# MULLER ADDITION

RE: SUB2001-00125 MULLER ADDITION

At the regular meeting of the Subdivision Committee of the Metropolitan Area Planning Commission on Thursday, January 3, the above captioned plat was considered. The action of the Committee was to approve the final plat, subject to the following:

**CASE NUMBER:** SUB 2001-125 – MULLER ADDITION

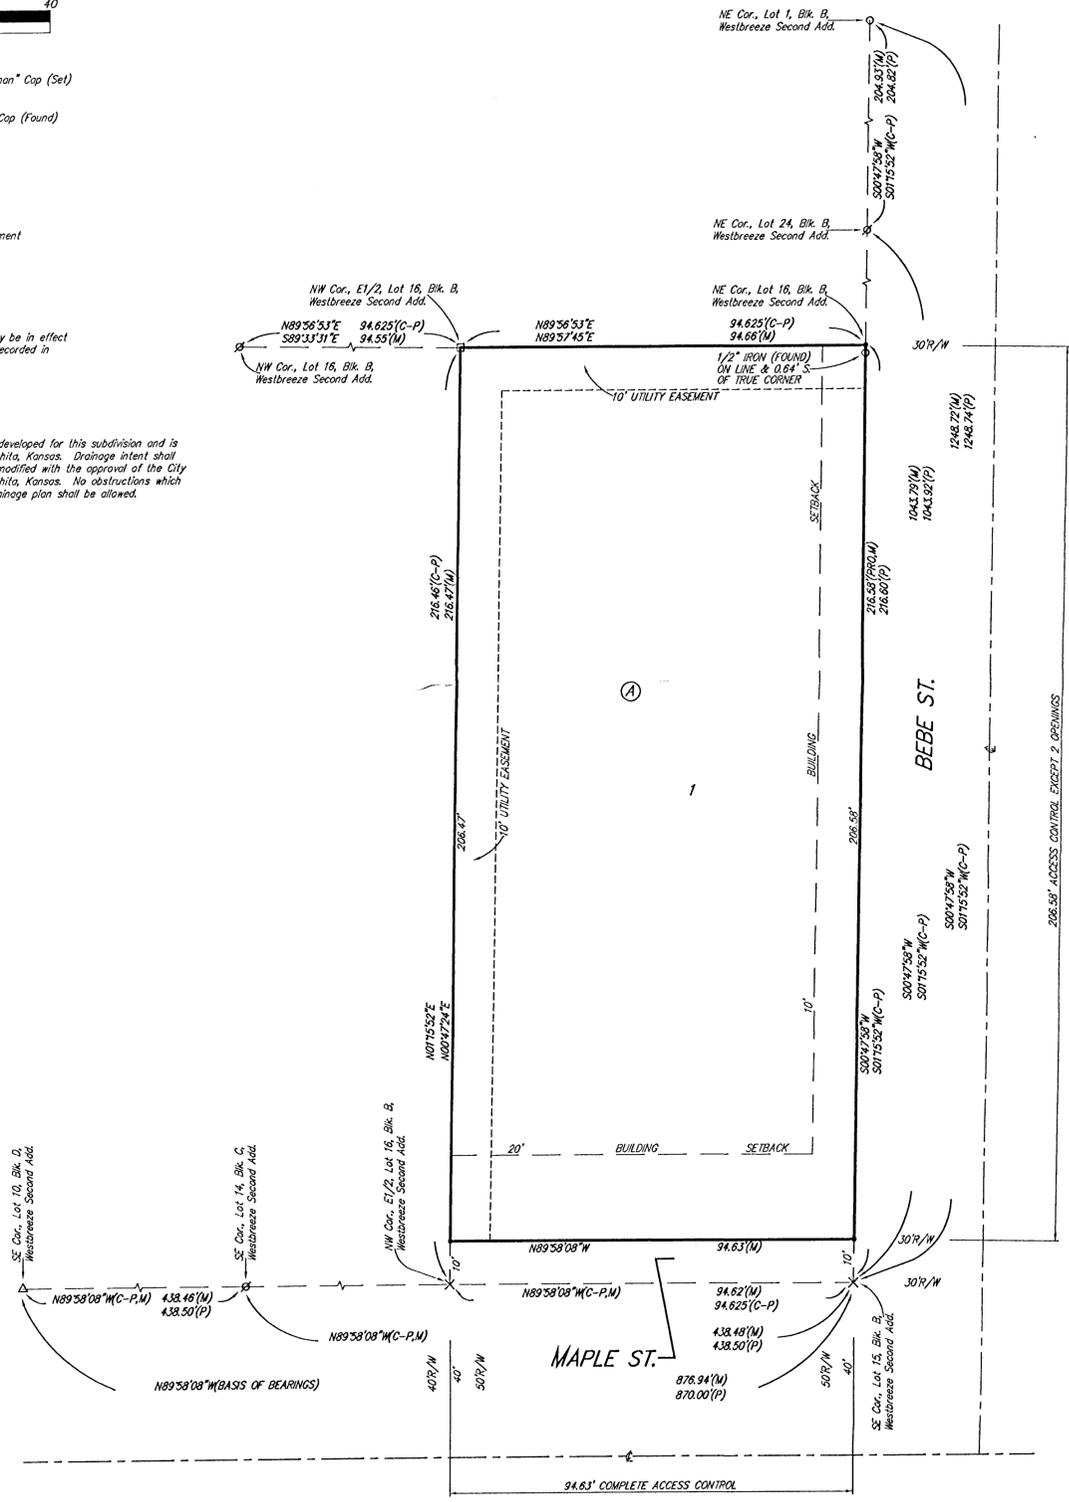
- C. City Engineering needs to comment on the status of the applicant's drainage plan. The drainage plan is approved.
- D. In accordance with the zone change approval, the plat proposes complete access control along Maple and two access openings along Bebe.

- F. As a commercial lot abutting a non-arterial street, the Subdivision regulations require a sidewalk along Bebe. A Sidewalk Certificate will be needed.

- G. Based upon the legal description shown on the plat, the site involves a 10-ft dedication of street right-of-way for Maple. The plat's text shall reference such dedication.

- J. The Applicant has platted a 10-ft building setback along Bebe which represents an adjustment of the Zoning Code standard of 20 feet for the NR District. (Bebe is classified as the Lot Frontage due to access from this street.) The Subdivision Regulations permit the setback provisions to be modified by the plat upon the approval of the Planning Commission.

- L. The plat's text shall include language that a drainage plan has been developed for the plat and that all drainage easements, rights-of-way, or reserves shall remain at established grades or as modified with the approval of the applicable City or County Engineer, and unobstructed to allow for the conveyance of stormwater.
